**Palo Verde
Nuclear Generating Station**
P.O. Box 52034
Phoenix, AZ 85072
Mail Station 7636
Tel 623 393 5379

102-07881-MEK/JR
October 22, 2019

Subject: **Palo Verde Nuclear Generating Station (PVNGS)
Units 1, 2, and 3 Docket Nos. STN 50-528, 50-529, 50-530
2019 Post-Exam Comments and Analysis Submittal**

Recommended Changes to the 2019 PVNGS NRC Initial Written Exam

Figure 2-2 Screening for SRO-Only Linked to 10 CFR 55.43(b)(5)
(Assessment and Selection of Procedures)

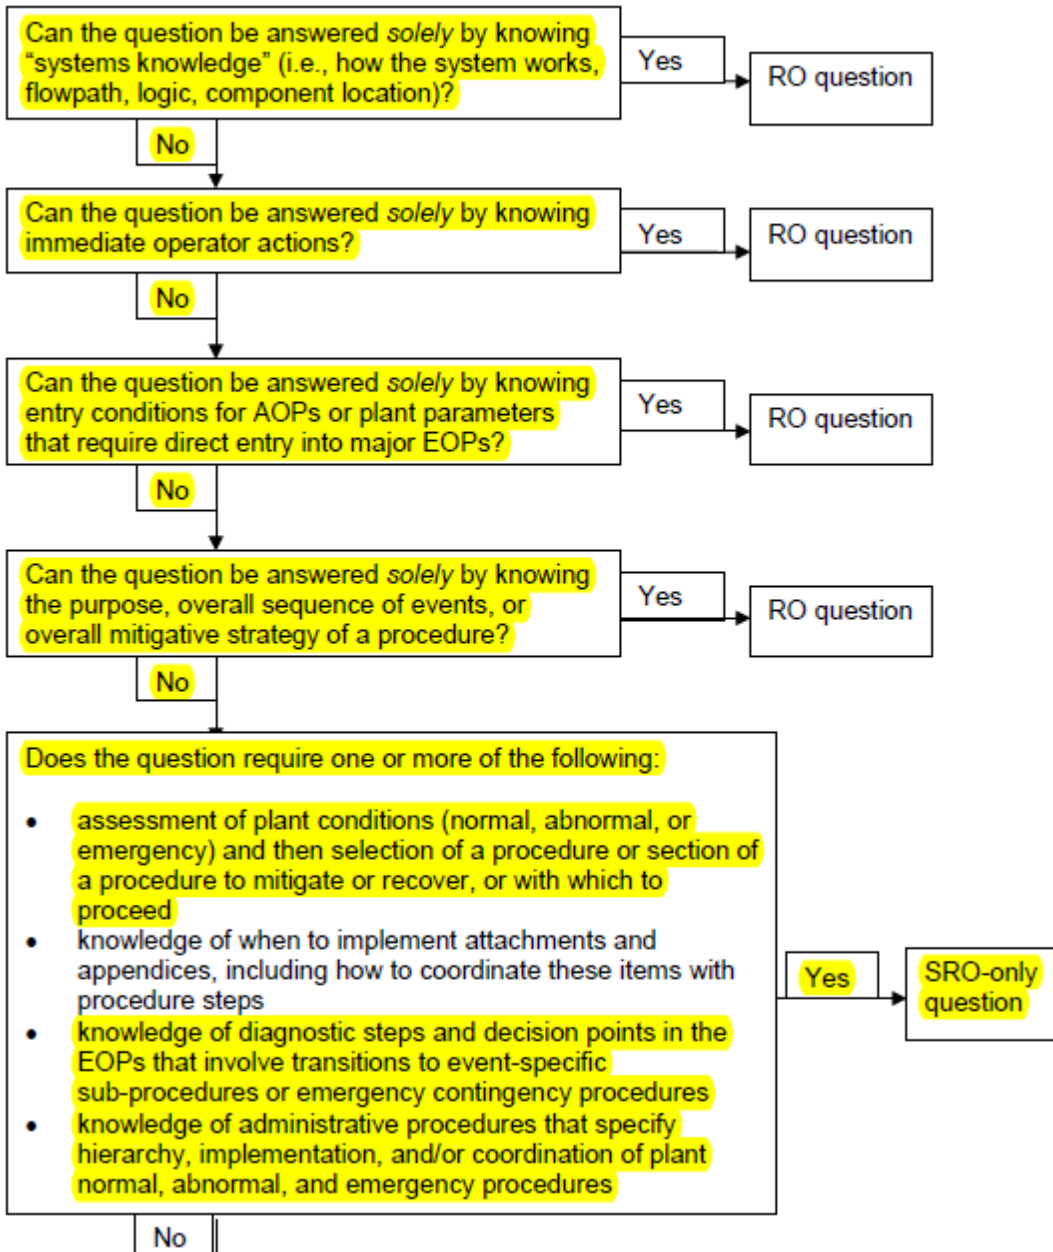
Facility Position: In the stem of the question, Unit 1 has been in a blackout for 50 minutes. As such, it is reasonable for the examinee to either determine that performance of 40MG-9ZZ07, FLEX Support Guidelines is NOT required because an hour has not yet elapsed since the start of the blackout condition. It is also reasonable to determine, given the conditions in the stem, that it is likely the blackout condition will exist for greater than one hour, in which case an ELAP would be declared and performance of 40MG-9ZZ07 would be required. The information presented in the stem provides a situation in which an SRO would be within their positional discretion to either wait the full 60 minutes, then implement 40MG-9ZZ07, FLEX Support Guidelines, or, based on their assessment of plant conditions, determine that an ELAP is imminent, which would then require implementation of the FLEX Support Guidelines.

Per Step 13 in 40EP-9EO08, Blackout, "IF at least one vital 4.16 kV AC bus is NOT expected to be energized within one hour of the start of the event from either offsite power, an Emergency Diesel Generator, or an SBOG" then the contingency actions would be performed. If the applicant expects that power will be available from one of those sources, they would NOT proceed to the contingency actions, which is where 40MG-9ZZ07, FLEX Support Guidelines, is directed.

Step 13.2 (contingency action for step 13) in 40EP-9EO08, Blackout, states, "IF AC power will NOT be available from offsite power, an SBOG, or any Unit's EDG within one hours of the start of the event (ELAP), THEN perform the following: Declare an ELAP is in progress and PERFORM 40MG-9ZZ07, FLEX Support Guidelines". The way this step is worded, the requirement to implement the FLEX Support Guidelines BEFORE one hour has elapsed is based on the assessment of whether or not power may be restored before one hour has elapsed. If the CRS has determined that power may be restored before one hour has elapsed, FLEX Support Guidelines is NOT required. If the CRS has determined that power will NOT be restored before one hour has elapsed, FLEX Support Guidelines IS required.

Exam Author Perspective: When I wrote the question, I intended for the student to assume that power would not be restored within an hour of the event. The reason I wrote the question 50 minutes into the blackout instead of greater than one hour was to enhance the plausibility of distractors 'B' and 'D'. In doing so, I believe that I increased the ambiguity of the question which resulted in the examinees being forced to make an assumption about the restoration of power which would be required to answer the question. In hindsight, I would have placed Unit 1 > one hour into the blackout to conclusively state that an ELAP was in progress to ensure that only one answer could be argued as correct.

Facility Recommendation: Per NUREG 1021, ES-403, Section D.1.b, the question contained “an unclear stem that confused the applicants or **did not provide all the necessary information**” to conclusively answer the question.

Although ‘A’ and ‘B’ part 2 (IS and IS NOT required) are conflicting, they are each correct based on two different but valid assessments of the given conditions. Based on ‘C’ and ‘D’ being clearly incorrect, and either ‘A’ or ‘B’ being correct based on CRS judgment, our recommendation is to either accept both ‘A’ and ‘B’ as correct or remove the question from the exam since neither ‘A’ nor ‘B’ can be conclusively justified as incorrect.

**Figure 2-2 Screening for SRO-Only Linked to 10 CFR 55.43(b)(5)
(Assessment and Selection of Procedures)**

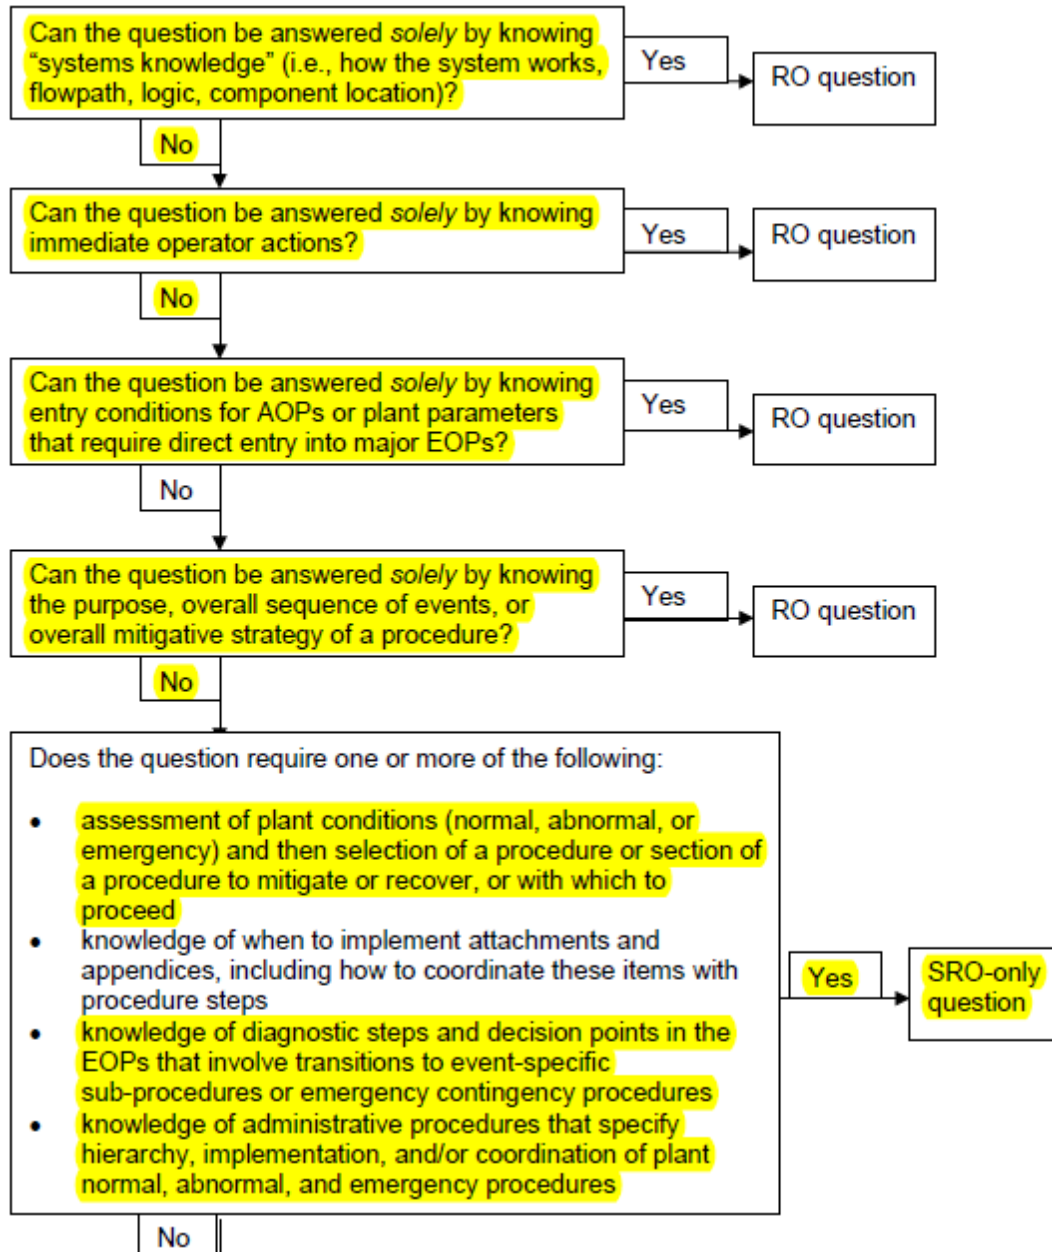
Facility Position: 40EP-9EO07, Loss of Offsite Power / Loss of Forced Circulation, was modified in February of 2018 to reflect the change from 117°F as the maximum containment temperature to satisfy the Containment Temperature and Pressure Control safety function during both a loss of offsite power and a loss of forced circulation. The EOP modification kept maximum containment temperature for a loss of forced circulation at 117°F, but modified the maximum containment temperature for a loss of offsite power to 125°F. However, 40DP-9AP12, Loss of Offsite Power / Loss of Forced Circulation Technical Guideline, still indicates that the maximum containment temperature required to satisfy the Containment Temperature and Pressure Control safety function for a Loss of Offsite Power or Loss of Forced Circulation event is 117°F:

Exam Author Perspective: When I developed the question, I assumed that the Containment Temperature and Pressure Control safety function limit was the same in the EOP and the EOP Tech Guideline and did not check to ensure they matched. Since the Tech Guideline for each EOP provides amplifying information for the associated EOP, they should match. Although I routinely use the EOP Technical Guidelines for exam questions, I didn't see the need to reference or check it for this question as the information was identified in the EOP. Had I recognized the difference while I was

Facility Recommendation: Per NUREG 1021, ES-403, Section D.1.b, the question contained “**newly discovered technical information that supports a change in the answer key**”.

Based on having two approved EOP documents with conflicting information about the maximum allowable temperature following a Loss of Offsite Power event, we recommend accepting both ‘A’ and ‘C’ as correct answers due to approved technical documents listing both 117°F and 125°F as the containment temperature safety function limit for a Loss of Offsite Power.
